SIB 65 20 19

2023-03-13

## RECALL CAMPAIGN 19V-698: DRIVER'S FRONT AIR BAG MODULE – PRIOR PARTS REPLACEMENT

This Service Information Bulletin (Revision 4) replaces SI B65 20 19 **dated February 2022**.

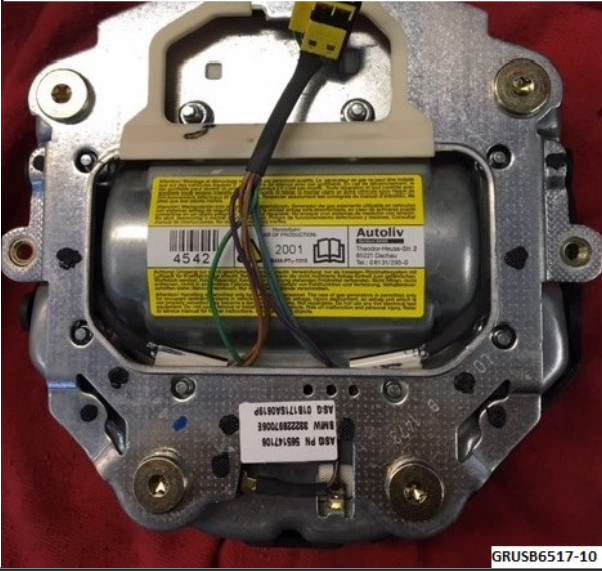
2. Check the label on the back of the driver's air bag.

Is the label yellow with a white number sticker with printed serial number **BAM PT1-1085** (as shown on left) printed below the bar code?

**YES**- replace air bag

**NO** - the driver's air bag is not affected.

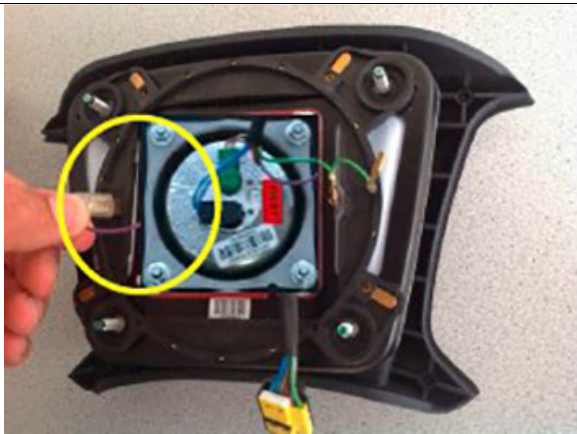
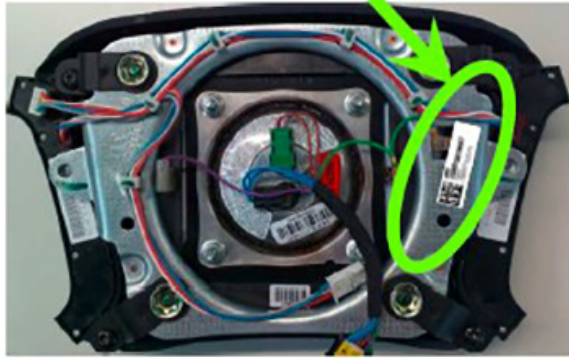
**On vehicles with a basic steering wheel, the horn ring must be removed from the new part. To do so, proceed as follows:**

<p>1. Remove horn ring.</p> <ul style="list-style-type: none"> <li>• Unplug the connector for the grounding cable (see the green arrow in the figure)</li> <li>• Remove the nuts (see the blue mark in the figure, Torx 55).</li> </ul>
	<ul style="list-style-type: none"> <li>• Take off the horn ring, making sure that the springs remain in place.</li> <li>• Remove the horn contact plate.</li> <li>• Separate components after disassembly:             <ol style="list-style-type: none"> <li>1 - Air bag module</li> <li>2 - Horn ring</li> <li>3 - Horn contact plate</li> <li>4 - Torx nuts</li> </ol> </li> </ul>

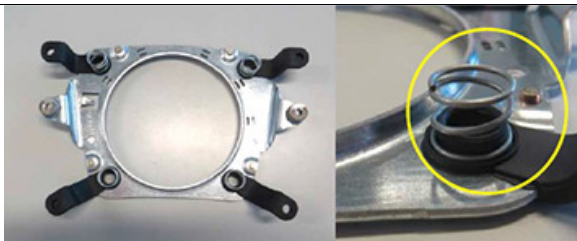
2. Prepare the new air bag module and pull off one of the two labels with the barcode and serial number of the air bag module.

This must be applied to the horn ring **after** installation.

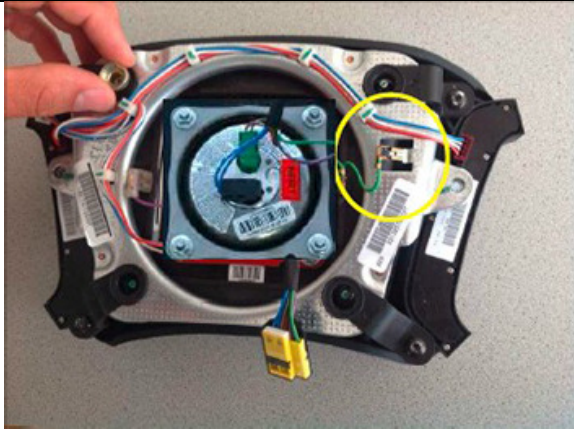
3. Place the horn contact plate on the new air bag module and plug in the connector.

4. Place the horn ring on the air bag module. Make sure the springs are seated correctly.

5. Plug in the connector for the grounding cable and secure the horn ring with the four Torx nuts.

Tightening torque: **5.0 +/- 0.2 Nm.**
